## Product / Process Change Notification (PCN)

**PCN #:** PCN\_RfMCA\_20210706

**Affected Series:** WE-MCA; 74889xxxxx

4. Correction and modification of land pattern shown in the datasheet for below articles

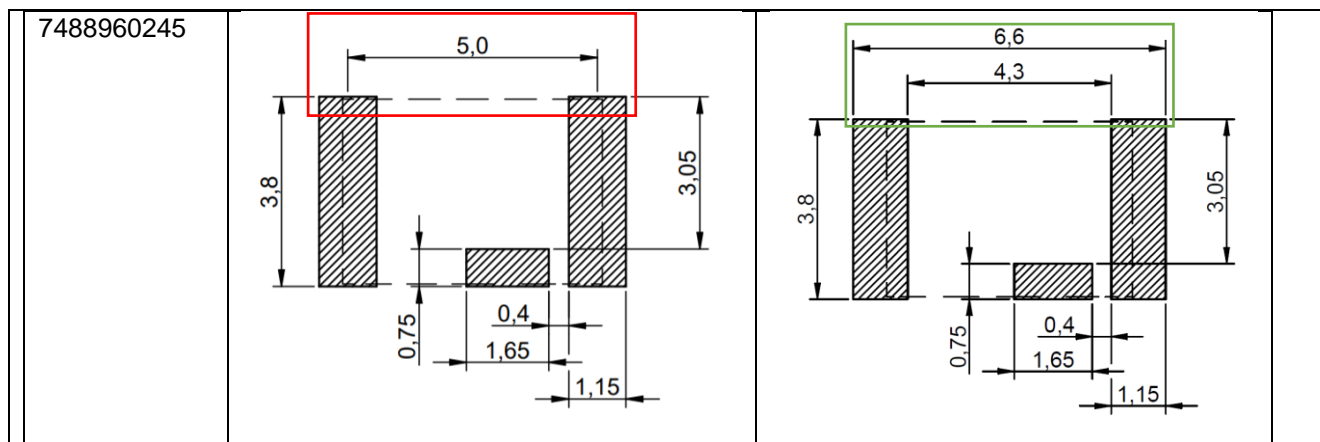
Part number	Changes	
	Before	After
7488922455		
7488910915		
7488920157
